Intersection ID: 15323	Main Street: FANNIE_CR	Cross Street: GENE_AV	Location:	E
ADA ID: B26DF94C5416	Ramp Type: ParaDiag	Initial Pass/Fail: Fail	Overall Compliance: No	Severity Score: 26.25

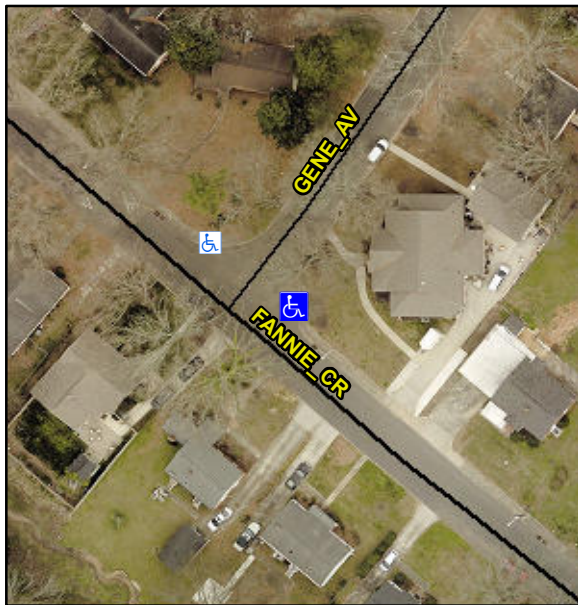
R304.3.2, R304.5.3

Compliance	Description	Data	Compliance	Description	Data
N/A	Ramp Length LT (in)	57.0	N/A	Ramp Length RT (in)	100.0
Yes	Ramp Width LT (in)	60.0	Yes	Ramp Width RT (in)	60.0
No	Ramp Slope LT (%)	12.7	Yes	Ramp Slope RT (%)	8.2
No	Ramp XSlope LT (%)	3.1	Yes	Ramp XSlope RT (%)	0.7
N/A	Landing Length (in)	N/A	N/A	DWS Provided?	N/A
N/A	Landing Width (in)	N/A	N/A	DWS Contrast?	N/A
N/A	Landing Slope (%)	N/A	N/A	DWS Length (in)	N/A
N/A	Landing X Slope (%)	N/A	N/A	DWS Full Width?	N/A
N/A	Landing Curb? (Y/N)	N/A	N/A	DWS Offset (in)	N/A
N/A	Shared Landing?	N/A			
N/A	Gutter Ponding?	N/A	N/A	Gutter Slope (%)	N/A
N/A	Gutter Lip Ht (in)	N/A	N/A	Gutter X Slope (%)	N/A
N/A	Painted X Walk1?	No	N/A	Painted X Walk2?	No
	X Walk 1 Direction	To NW		X Walk 2 Direction	To SW
N/A	X Walk 1 Width (in)	N/A	N/A	X Walk 2 Width (in)	N/A
	X Walk 1 Slope (%)	3.0		X Walk 2 Slope (%)	1.7
	X Walk 1 X Slope (%)	4.1		X Walk 2 X Slope (%)	2.5
N/A	Ramp inside XWalk1?	N/A	N/A	Ramp inside XWalk2?	N/A

Road Slope (%)	0.7	N/A	Clear Space?	N/A
	Road X Slope (%)	3.8	N/A	Clear Space to XWalk (in)	N/A
N/A	Any Obstructions?	N/A	N/A	Storm Grate/Utility Hazard?	N/A
	Obstruction Type			Storm Grate/Utility Type	
		N/A			N/A
			Yes	Surface Condition? (G/P)	Good
			N/A	Curb Slope (%)	2.0

Remove & Replace Curb Ramp With Two New Directional Ramps or Equivalent.
